## Purpose of Change—handset

**Re: Application for a Permissive Change Filing with FCC ID: EW780-9867-00**

The purpose of this document is to describe all the changes that are made on new model **CL82XY9** from the original model **CL82215** in order to meet the requirements.

Table 1. Type naming convention

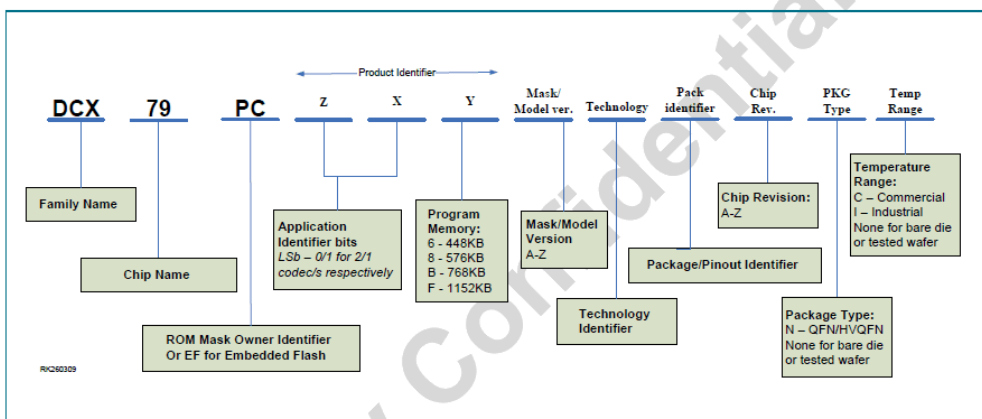
## 5. Handset RF IC is changed from DCX79VT213GS3ANC to DCX79VT214HS3ANC,

Refer to DCX79 technical spec, the different is

3G - memory size is "3" for 256KB ROM , Mask version is G.

4H - memory size is "4" 320KB ROM, Mask version is H.

but all RF part are the same
